# SAN FRANCISCO PLANNING DEPARTMENT

## Discretionary Review Abbreviated Analysis

*Date:* June 18, 2015  
*Case No.:* 2014-003161DRP  
*Project Address:* 2331 19<sup>TH</sup> STREET  
*Permit Application:* 2014.05.22.6466  
*Zoning:* RH-2 (Residential House, Two-Family) Zoning District  
40-X Height and Bulk District  
*Block/Lot:* 4076/017  
*Project Sponsor:* Karin Payson  
17 Jack Kerouac Alley  
San Francisco, CA 94133  
*Staff Contact:* Richard Sucre – (415) 575-9108  
[Richard.Sucre@sfgov.org](mailto:Richard.Sucre@sfgov.org)  
*Recommendation:* **Do Not Take DR & Approve the Project As Proposed.**

Discretionary Review Hearing  
Case Number 2014-003161DRP  
2331 19<sup>th</sup> Street

**Existing Conditions South Elevation**  
5/11/15

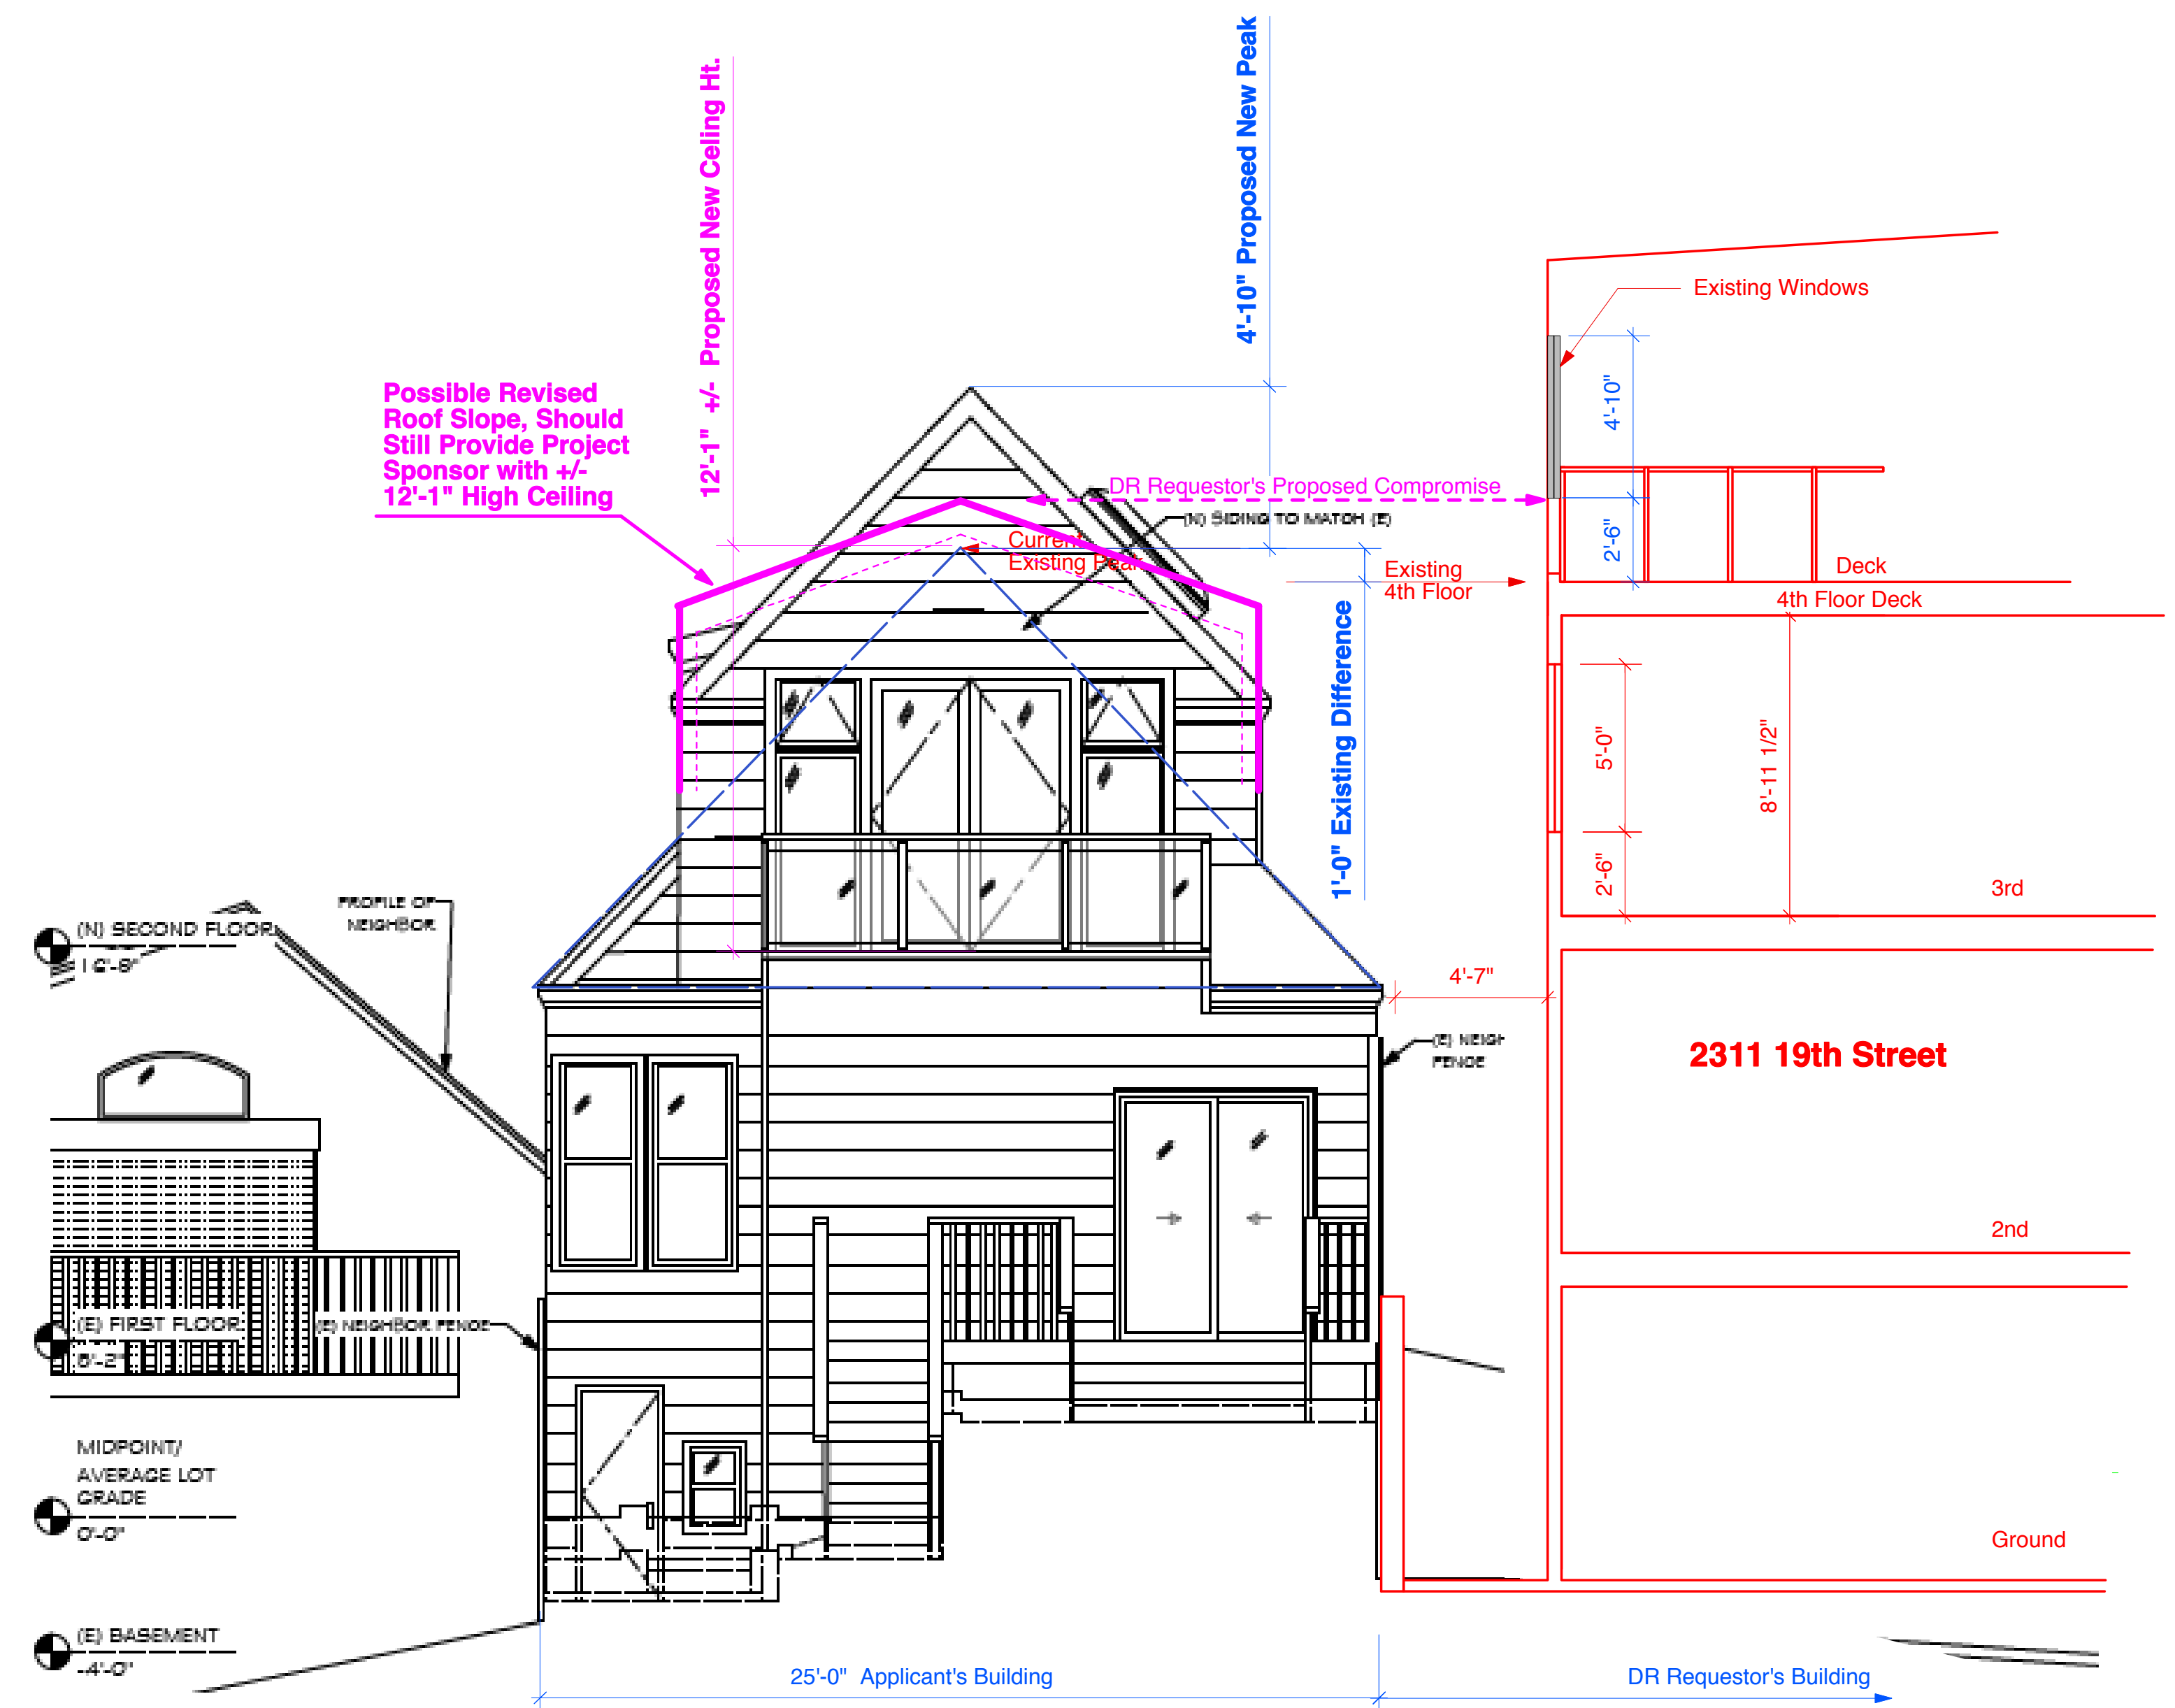
Since filing our request for discretionary review, we have had a number of meetings and conversations with our neighbors the project sponsors and their architect. We have been hoping that we could reach a compromise with them, and have submitted two different compromised designs. The first was flatly rejected and there has been no response to the second. This addendum briefly presents our recent compromise design and addresses our on-going concerns with their plans. Specifically, we are still concerned that Project Sponsor's drawings contain inaccuracies and that their proposed project is out of sync with the surrounding properties and does not respect the neighborhood topography.

- (3) Project Sponsors proposed to replace the glass rail on their roof deck with a privacy wall. Because a tall wood privacy wall would have a negative effect on the light to our home, and cause the addition to seem even larger than proposed, we declined the proposal.

We appreciate the challenges in such a major construction project, and have worked in good faith to reach a resolution. Unfortunately, Project Sponsors have rejected our efforts to reach a private compromise. We therefore respectfully request that you exercise your powers to revise the project, and accept our second proposed compromise, which will give Project Sponsor's all the square footage they seek, a cathedral ceiling in the master suite, but better correspond to the surrounding properties and protect our light and rear yard open space.
